|   Gachsaran Polymer Industries Company PIDMCO | Gachsaran Polymer Industries Company HDPE Plant | |  | | |
| | LCP and Junction Box Layout, Arrangement and Wiring Drawing for Refrigerator Package | |   | | |
| PO No.: GPIC-PT-MA-PO-000-3029 | Document Number: VD-GPIC-MA-3029-3029-0046 | Rev. 02 | Page 1 of 14 | | |

| Code2 | <input checked="" type="checkbox"/> No Comment/ Approved with Note(s) Vendor/Sub-Contractor shall correct, revise and resubmit the document. The document is released for Manufacturing if changes incorporated. |

| VD-GPIC-MA-3029-3029-0046 | 02 | 13 OF 14 | A3 |

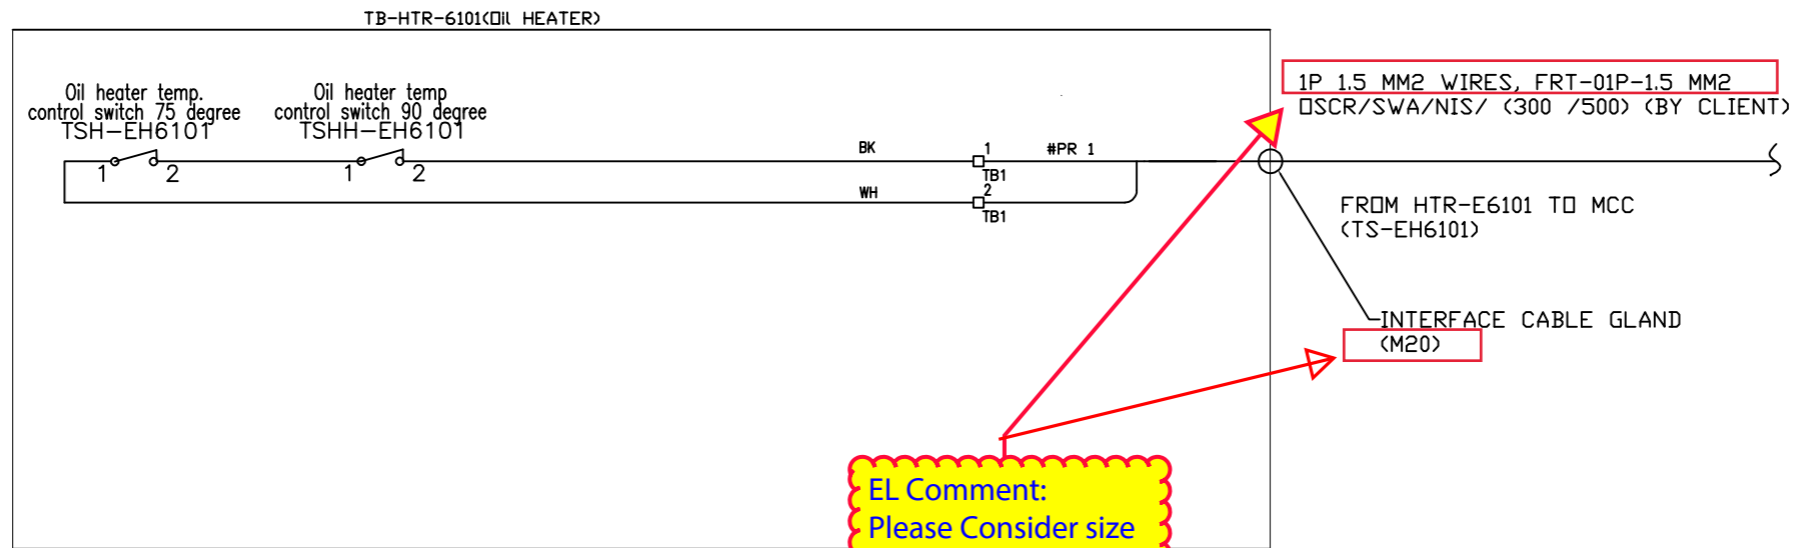
EL Comment:
Please Consider size 4 for this cable & Please consider M25 for gland on equipment
Vendor Reply:
Following to our meeting, M20 confirmed by Client.
